REMARKS:

Appl. No. 10/071,013
Prel. Amdt. Dated Feb. 9, 2004
Annotated Sheet Showing Changes

Figure 1
Prior Art - Current Amplifier

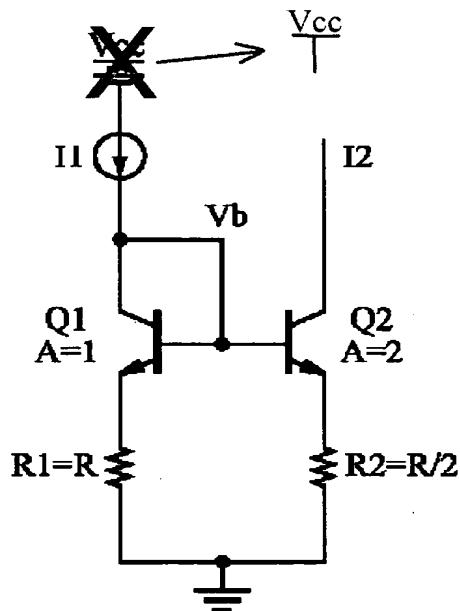
FIGs. 1, 1A, 2, 5 and 7 have been amended to show the proper symbol for Vcc. FIGs. 2, 5, and 7 have been amended to show the proper symbol for Vss. FIGs. 2, 5 and 7 have been amended to correct the direction of the current source symbols. FIG. 2 has been amended to show the proper input to transistor Q1. FIG. 6 has been amended to shown the proper input line to the negative terminal of current cell 10. FIG. 7 has been amended to show a connection dot and to connect current sources I1, I2, and I3 all to Vss. These changes are supported by the specification as filed.

Figure 2

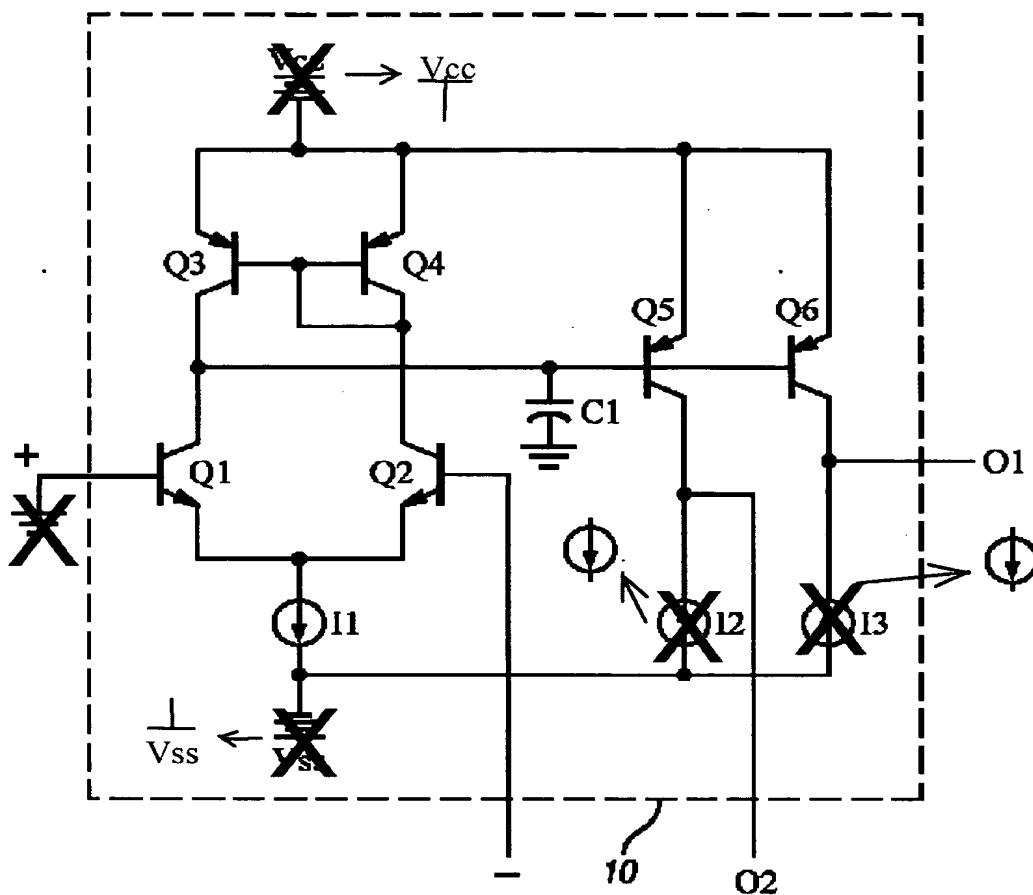
The specification has been amended to correct the characterization of transistors Q5 and Q6; they are not in a current mirror configuration and this is supported in Figures 2 and 5 as filed. The specification has also been amended to correct a typing error.
